STATE OF NORTH CAROLINA
DEPARTMENT OF TRANSPORTATION

Subject: **Addendum to Application for Section 404 Nationwide Permit 14, Section 401 Water Quality Certification, and Randleman Watershed Buffer Authorization** for the proposed widening of West Market Street (SR 1008) from Bunker Hill Drive (SR 2007) to NC 68 in Guilford County, Federal Aid Project No. STP-1008(9); Division 7; TIP No. R-2611

Reference: R-2611 NW14 Permit and WQC 3820 Application, November 30, 2010

PROJECT REFERENCE NO.	SHEET NO.
R-2611	18
RAW SHEET NO.	
ROADWAY DESIGN ENGINEER	HYDRAULICS ENGINEER
INCOMPLETE PLANS DO NOT USE FOR A/W ACQUISITION	
PRELIMINARY PLANS DO NOT USE FOR CONSTRUCTION

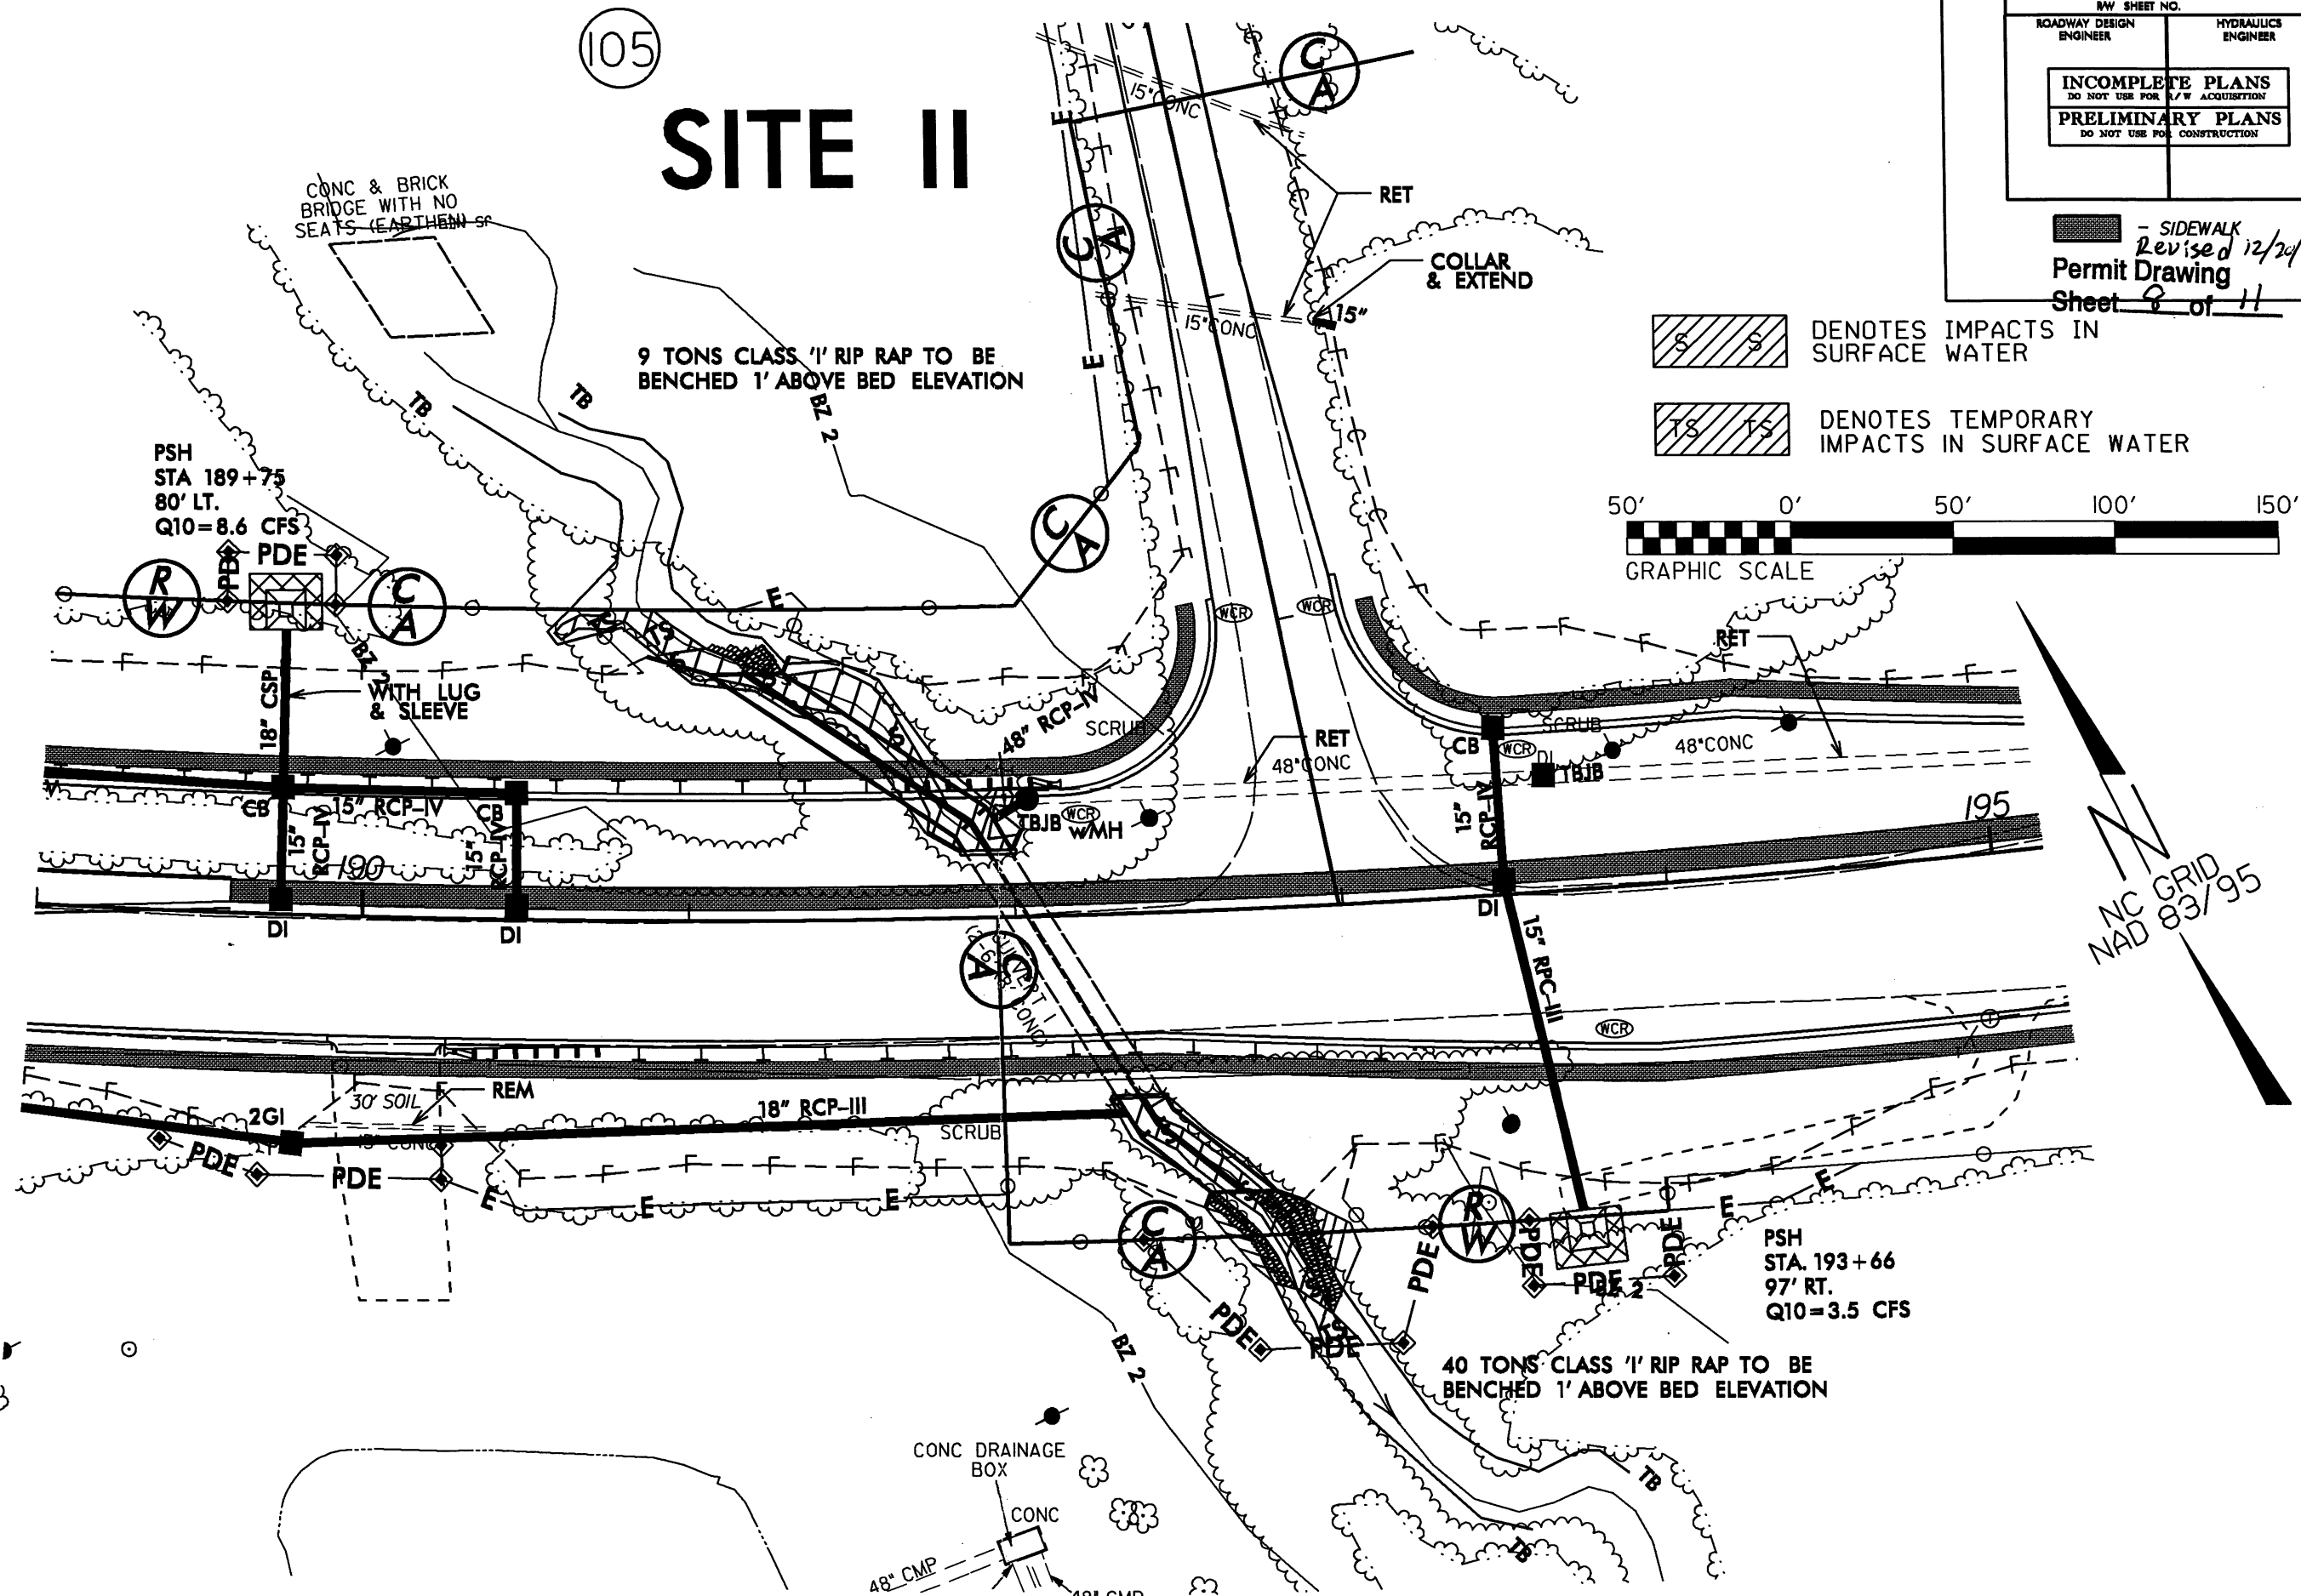
Rip rap has been placed in front of the high water culvert channel to function as a sill at Permit Drawing Site 2 (UT to East Fork of Deep River). This has caused the total permanent stream impacts to increase by 6 feet, while total temporary stream impacts have decreased by 6 feet. Total stream impacts requiring mitigation are now 200 feet. Total temporary stream impacts are now 49 feet. These changes are shown on Permit Drawing Sheets 6, 7, 8, 11 of 11 and Roadway Plan Sheet 18.

Revised 12/20/10
Buffer Drawing
Sheet 6 of 9

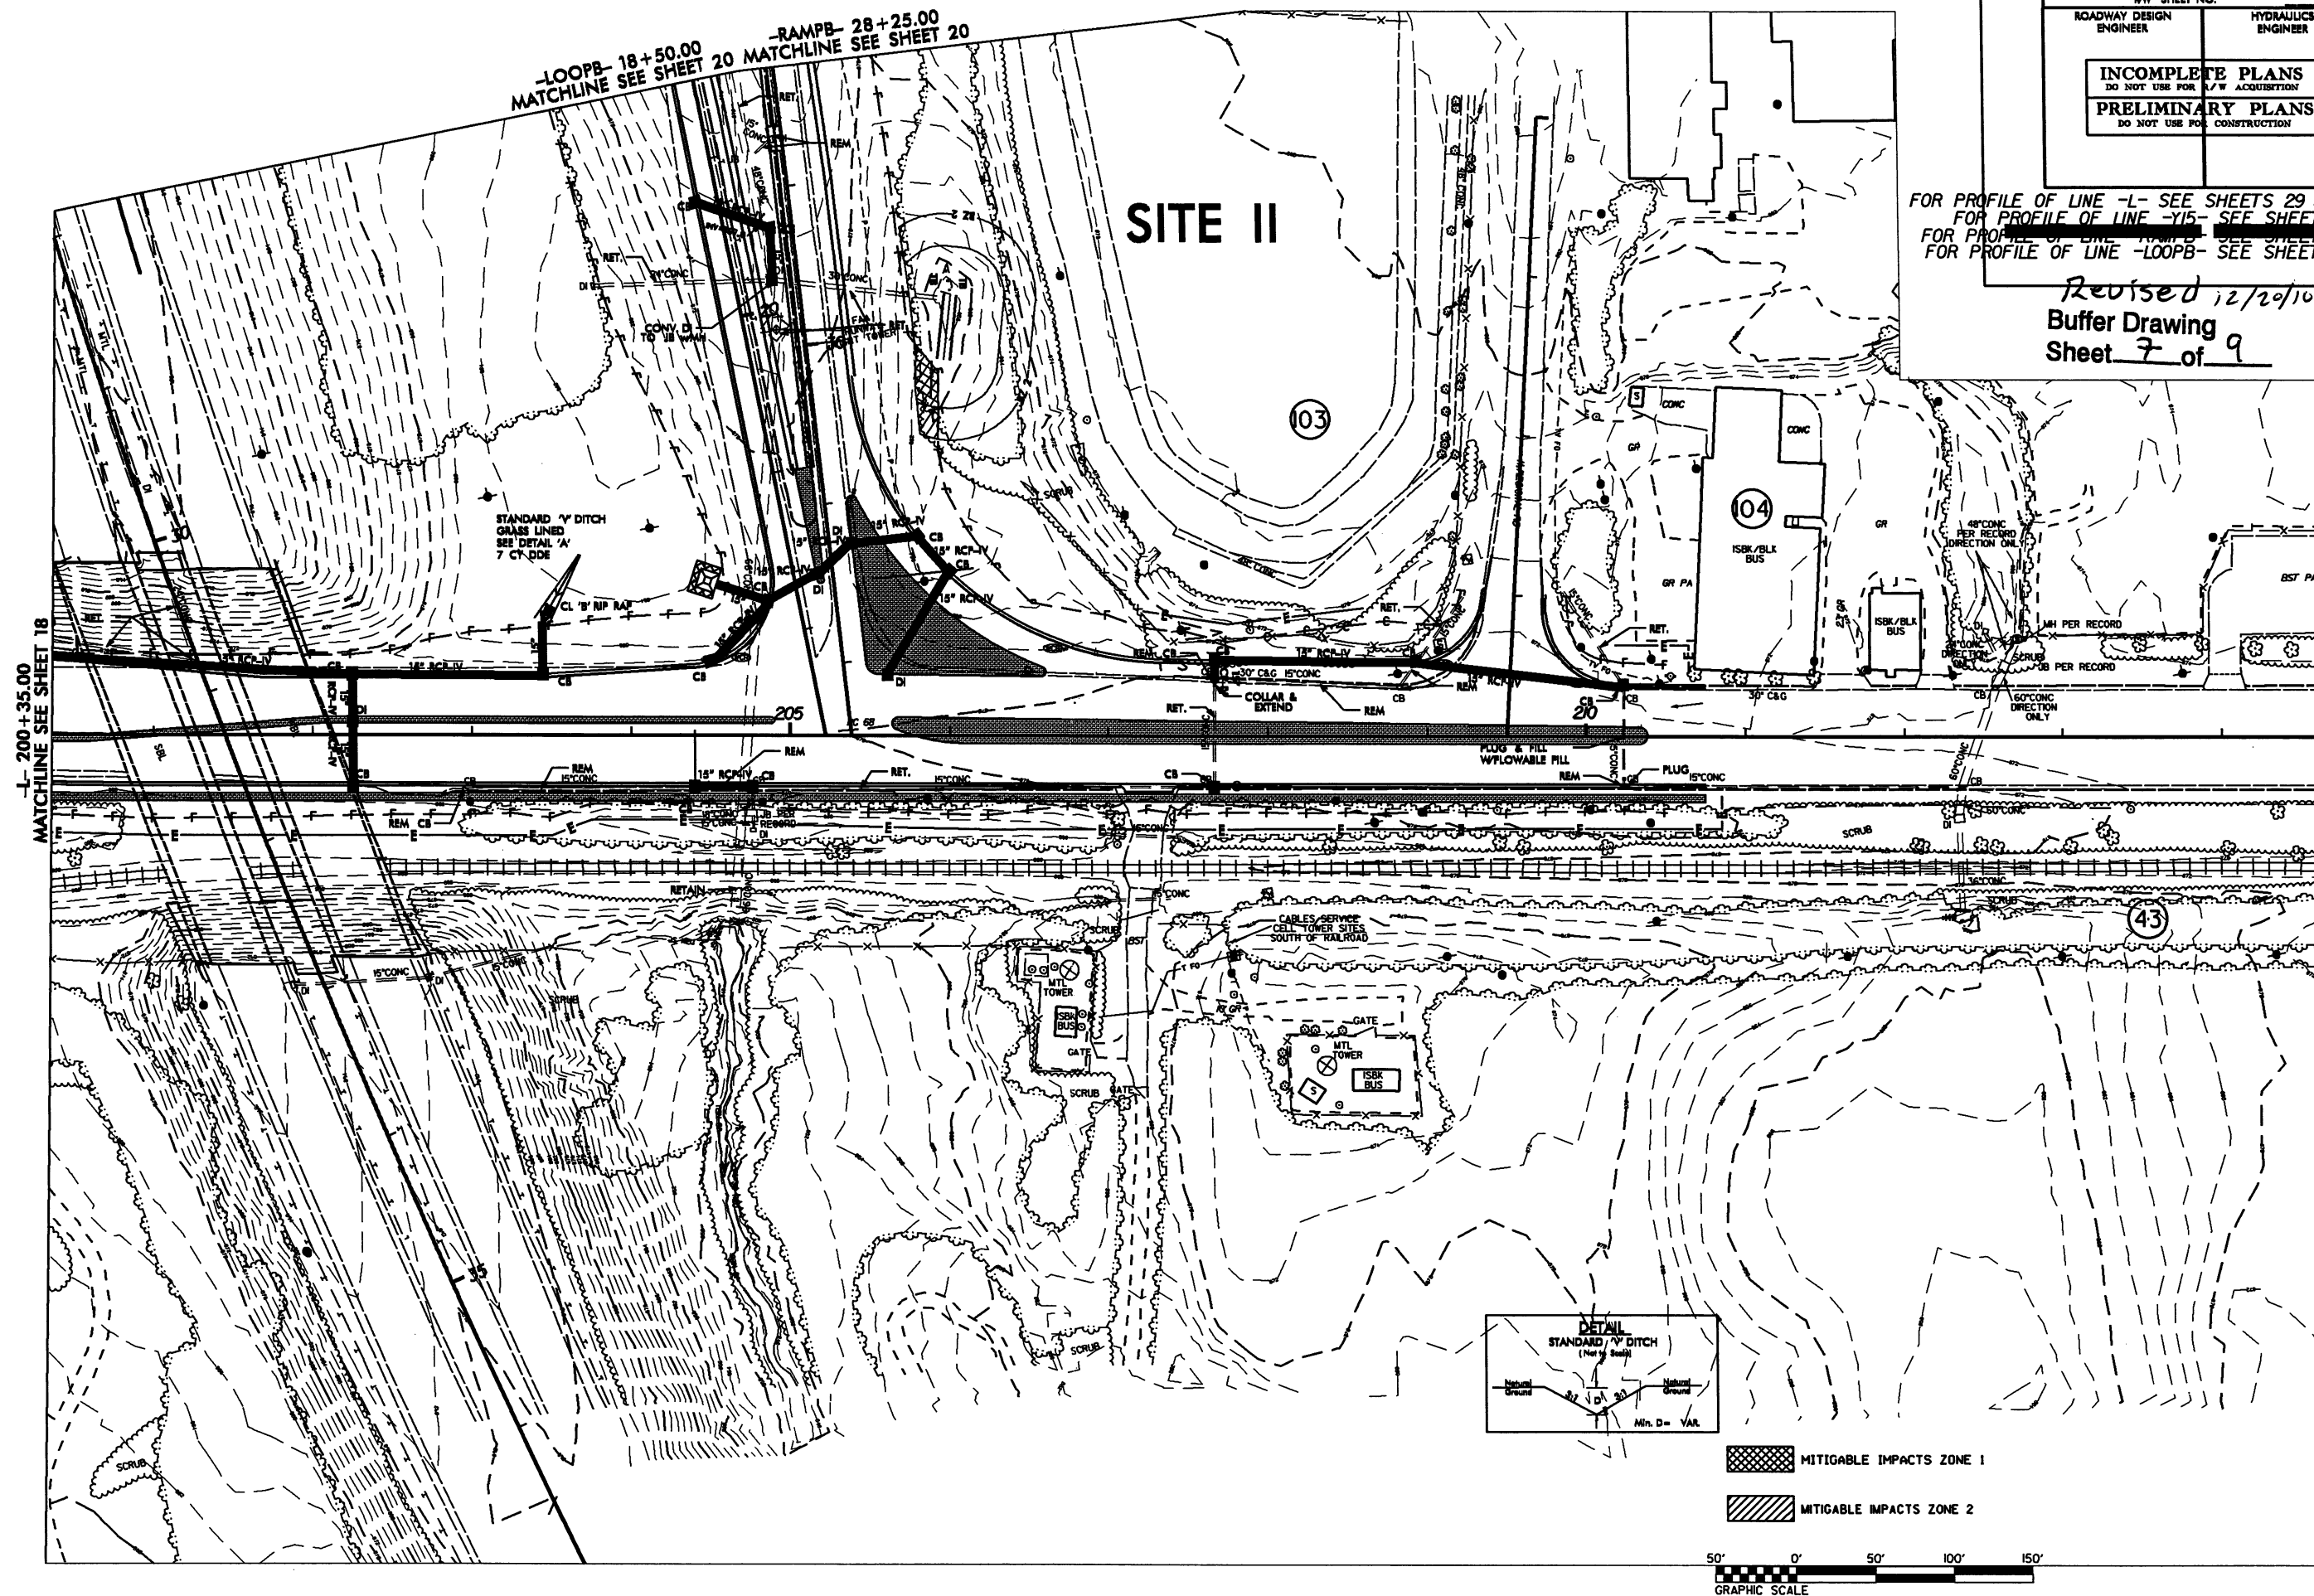
Stormwater drainage below Buffer Impact Site 2 was revised to allow for adequate treatment prior discharge into jurisdictional waters. This change is shown on Buffer Drawing Sheets 6, 7, 8 of 9 and Roadway Drawing Sheet 19. Total buffer impacts have not changed.
